Brunswick County Courthouse Addition & Renovations

Addendum 3

January 13, 2020

SAWYER SHERWOOD & ASSOCIATE ARCHITECTURE

AD1.0
01 of 03

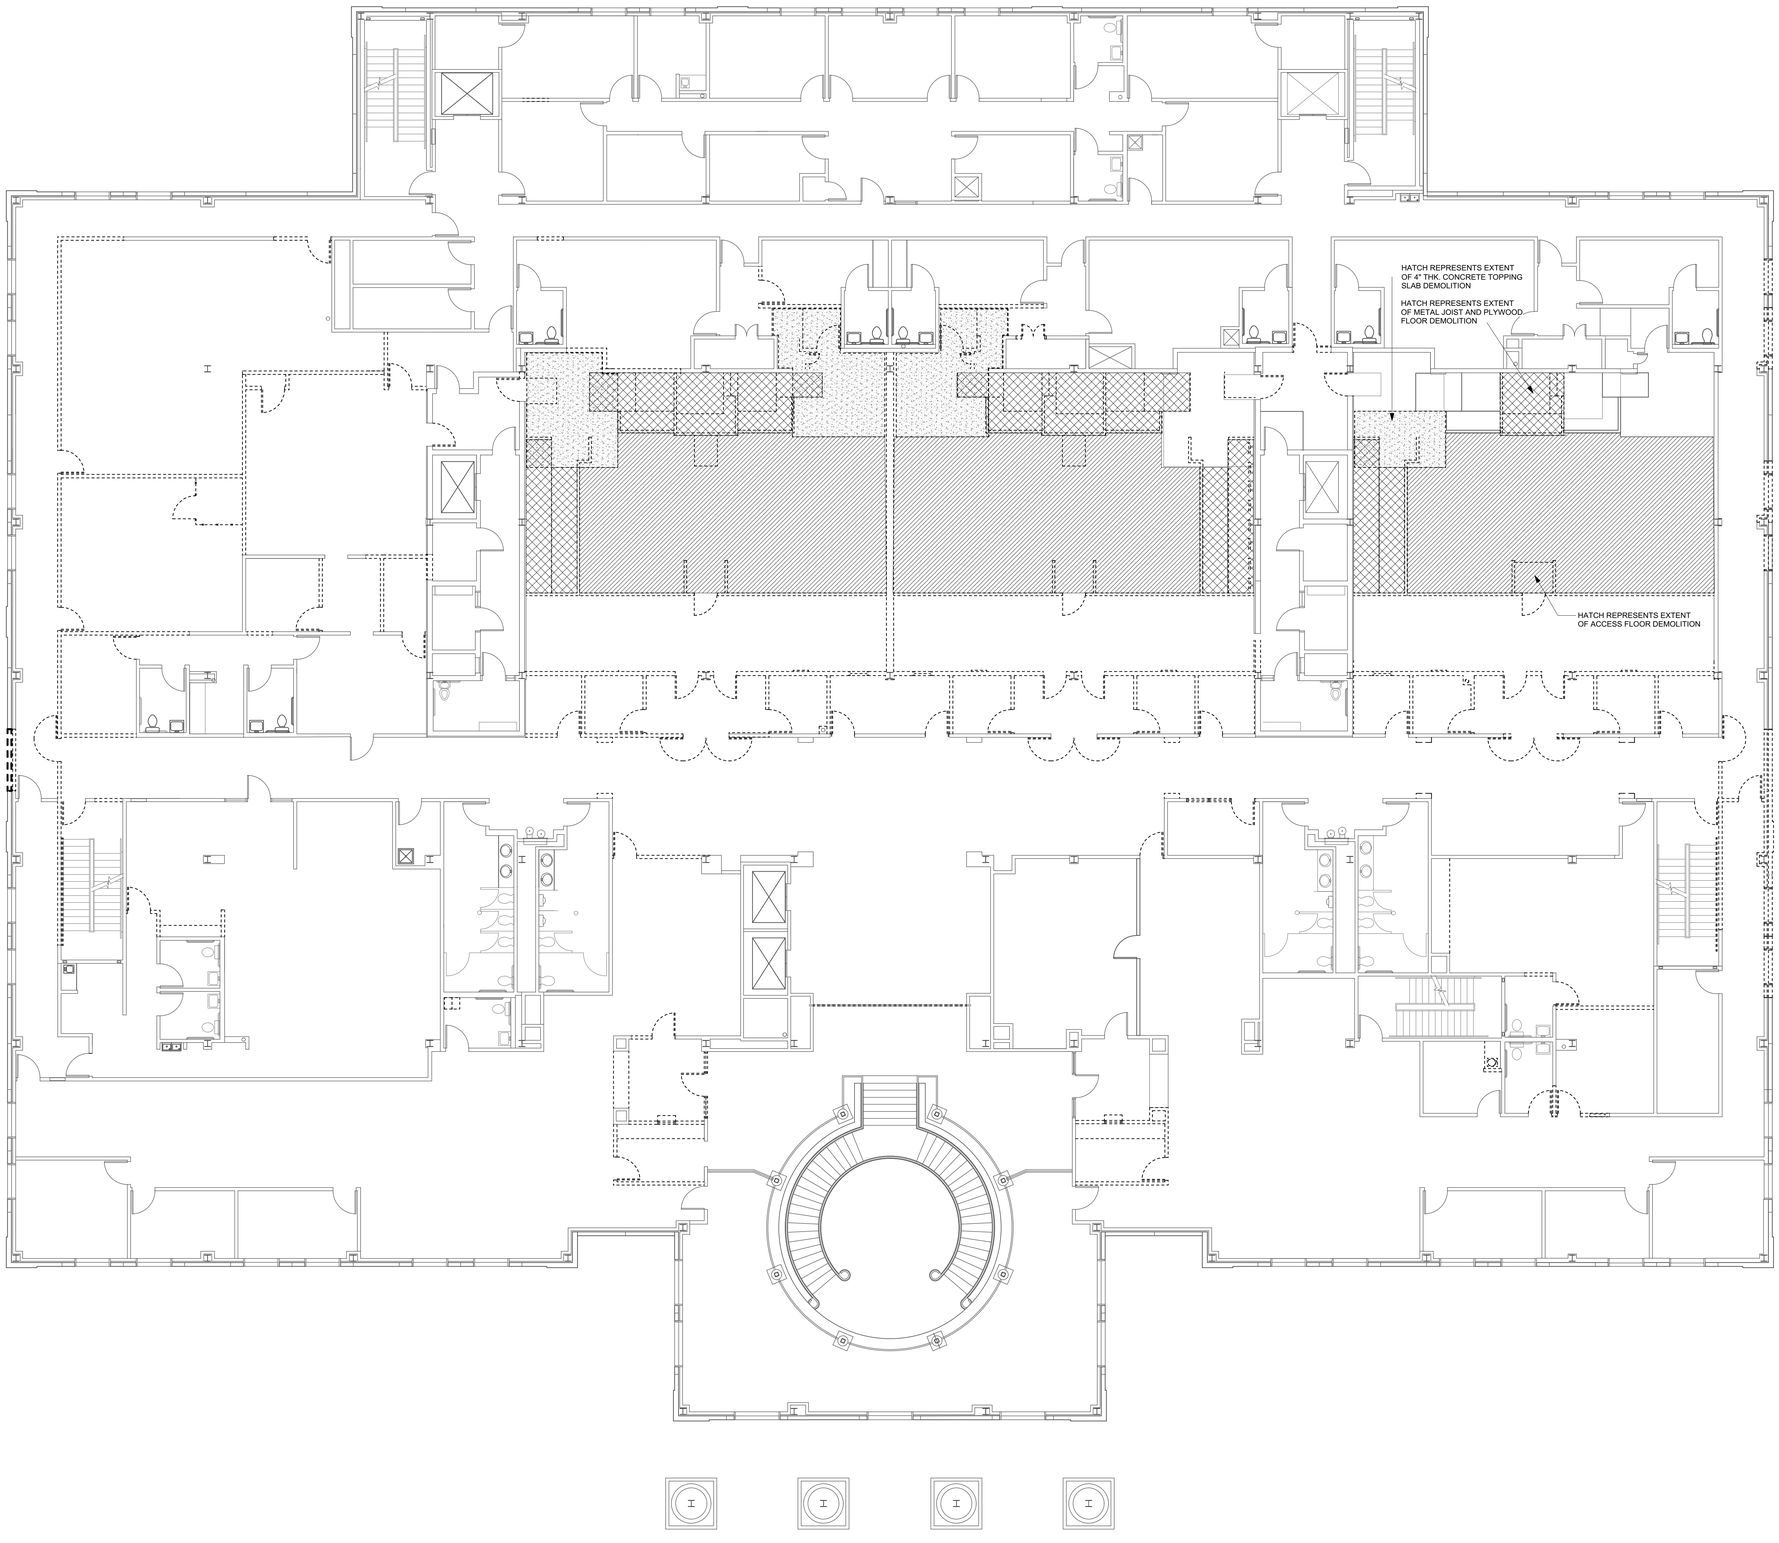
12. Sheets AD1.0 & AD1.1 are reissued and enclosed with the following clarifications and revisions:
    a. Courtroom floor construction demolition has been clarified.
    b. Existing floor plans (First Floor Plan & Second Floor Plan IN1.0, enclosed) showing existing seating and furniture are enclosed. Courtroom seating outside of the rail is stadium seating bolted to the floor. The contract scope includes removal and disposal of this seating, seating anchoring hardware and repair of floor slab in preparation for new floor finishes in the contract.
    c. Seating and furniture inside the rail shall be saved and reused. Construction contract scope includes safe storage or other protection of the existing furniture and reinstallation following renovations.

1 A1.1 Second Floor Plan
Scale: 1/8" = 1'-0"

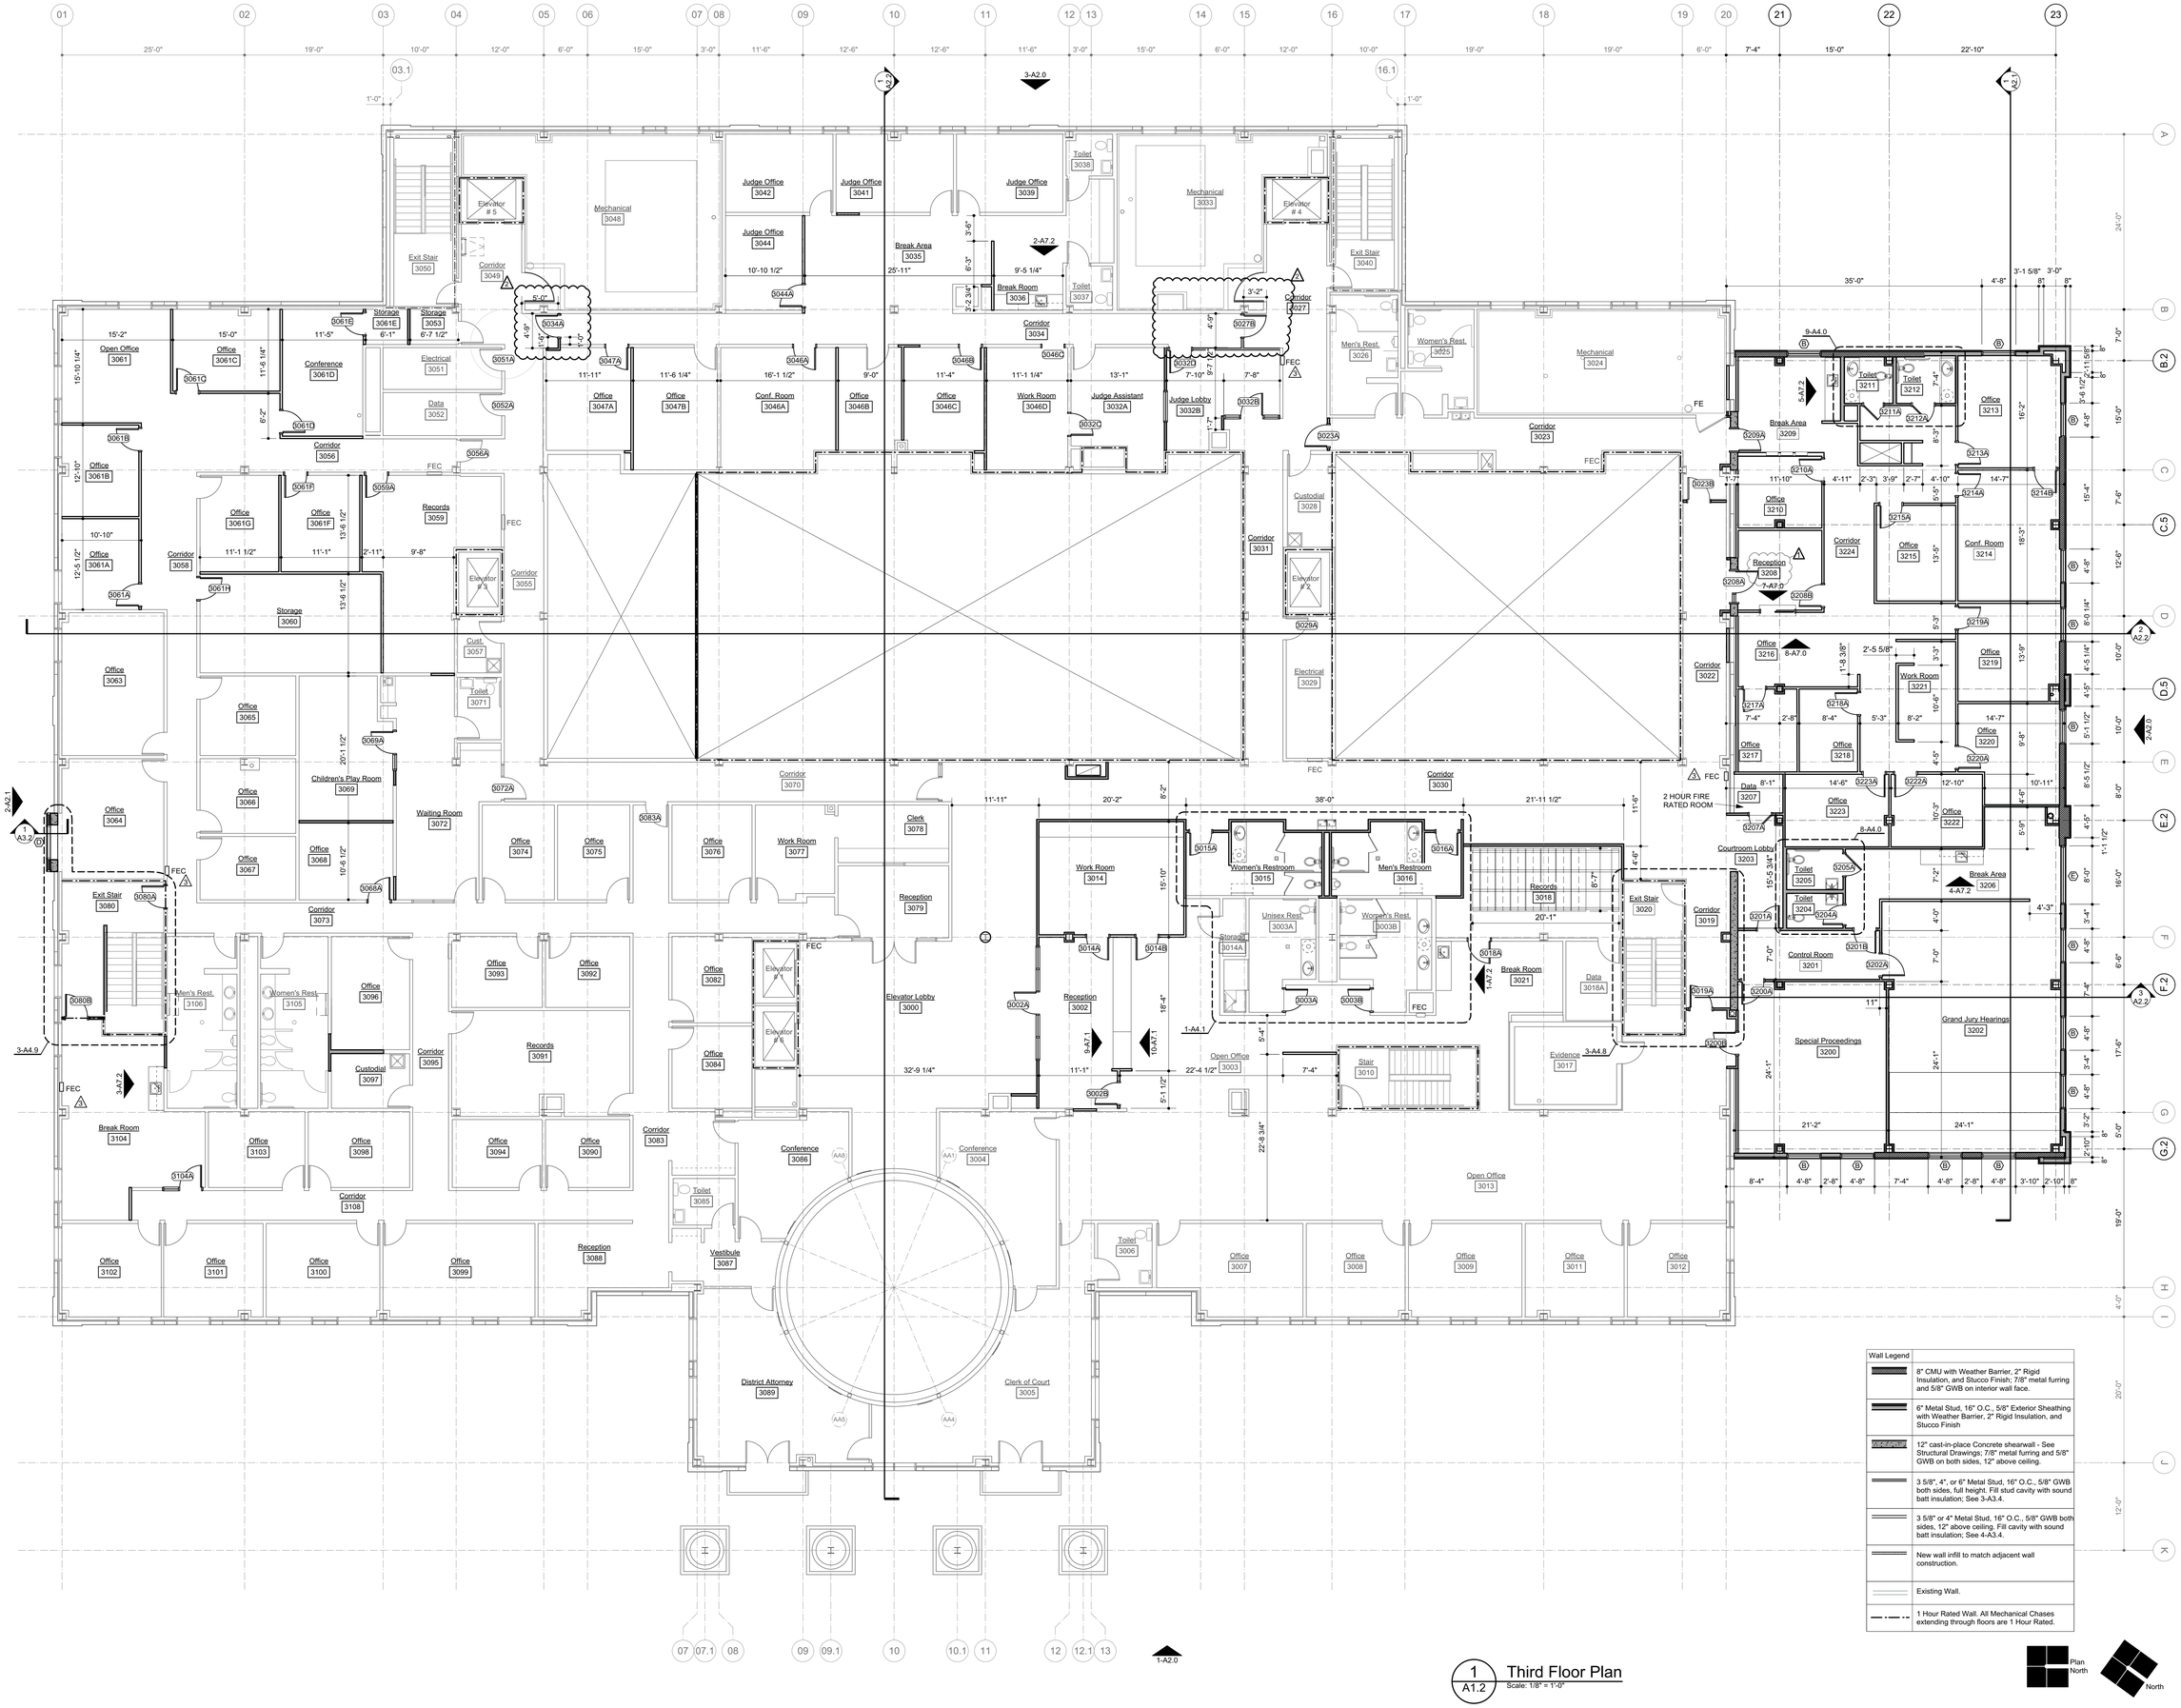
14. Sheet A1.1 is reissued and enclosed with the following clarifications and revisions:
    a. Courtroom entrance large format porcelain tile and cut metal letter signage has been added for courtroom 5 and courtroom 6. Courtroom entrances for courtrooms 1,2,3,4 & 7 are to be finished with large format porcelain tile and cut metal letter signage as shown in typical details on Sheet A 7.5. Minor ceiling grid revisions in the corridor outside of each courtroom may be required to accommodate.
    b. Fire extinguisher cabinets, existing to remain and new cabinets are added to the plans.

1 A4.5 Courtroom #5 Judge Casework Elevation
Scale: 3/8" = 1'-0"

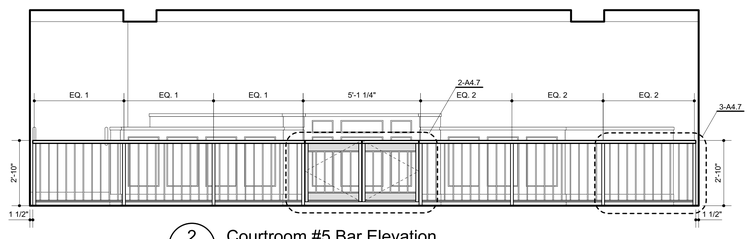
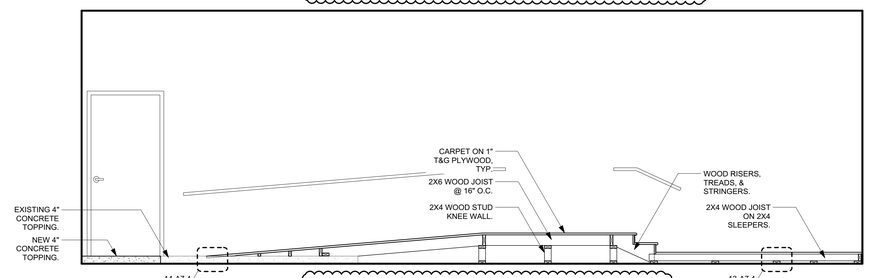
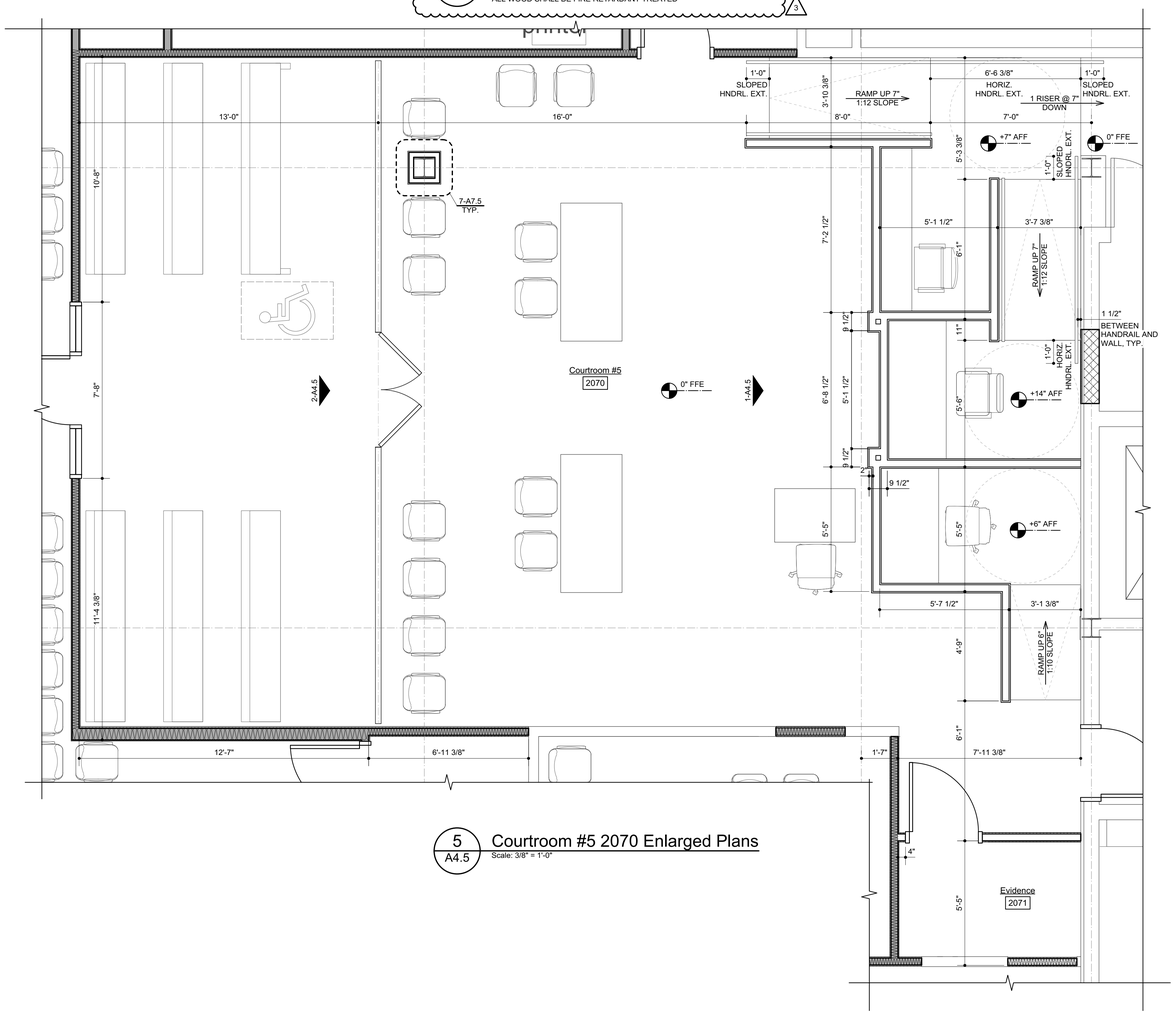
19. Sheet A4.5 is reissued and enclosed with the following clarifications and revisions:
    a. Detail Section at judge's bench in Courtroom #5 Judge Casework Elevation 1-A4.5 is changed from 2-A7.4 to 5-A7.4.
    b. Details 6 & 7 have been added.

15 A5.2 **GFRC Cornice @ Roof**
Scale: 1" = 1'-0"

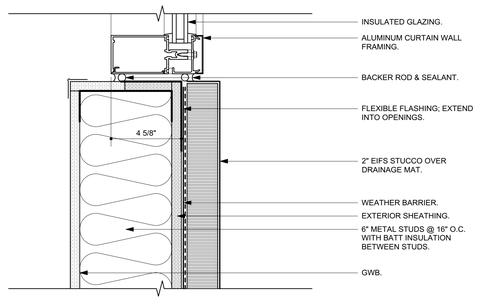
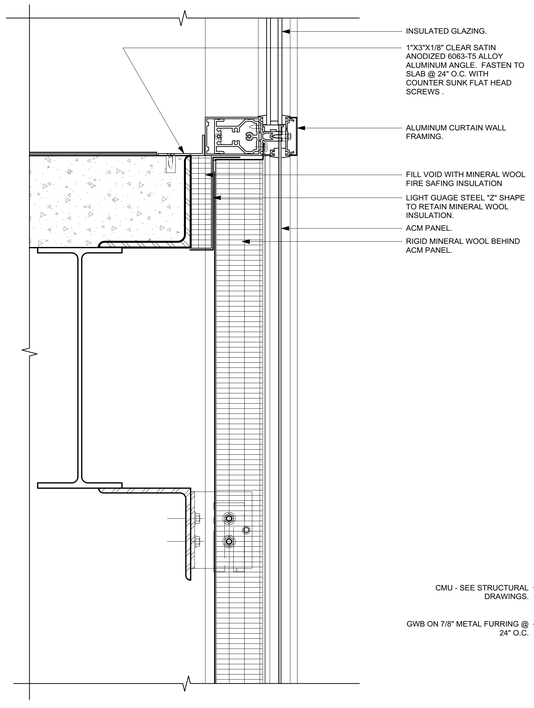
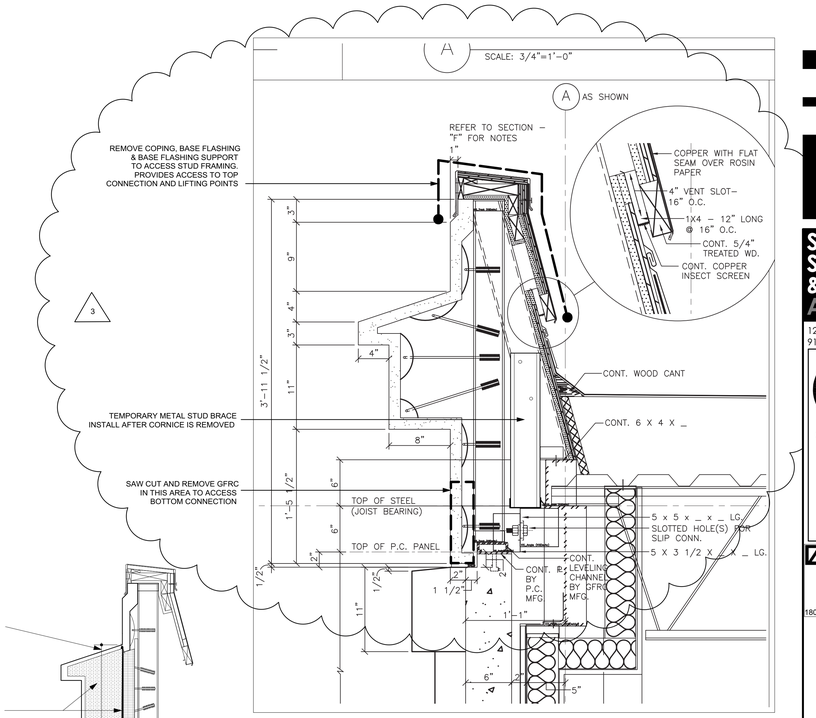
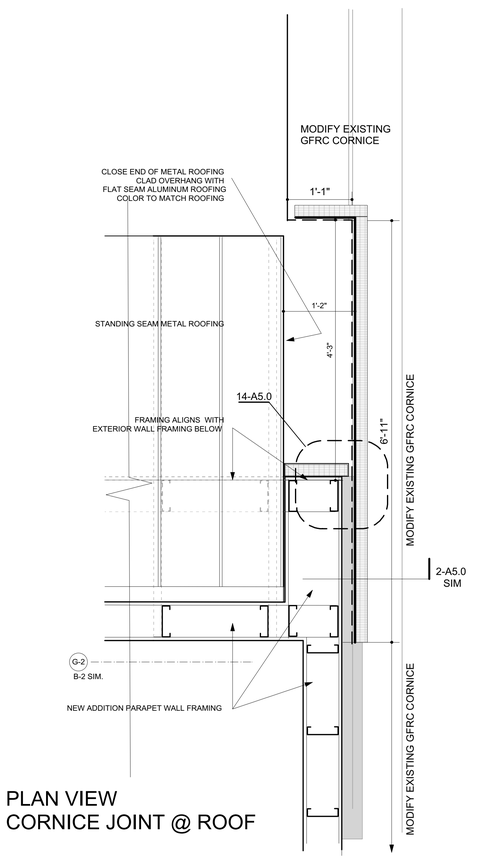
23. Sheet A5.2 is reissued and enclosed with the following clarifications and revisions:
    a. Added information on the existing cornice. The existing GFRC cornice must be removed along grid line 20 where the addition connects (also indicated on the roof plan). The existing cornice is in 16-foot lengths. The existing cornice detail including notes on how the cornice connections and original lifting point may be accessed is shown.
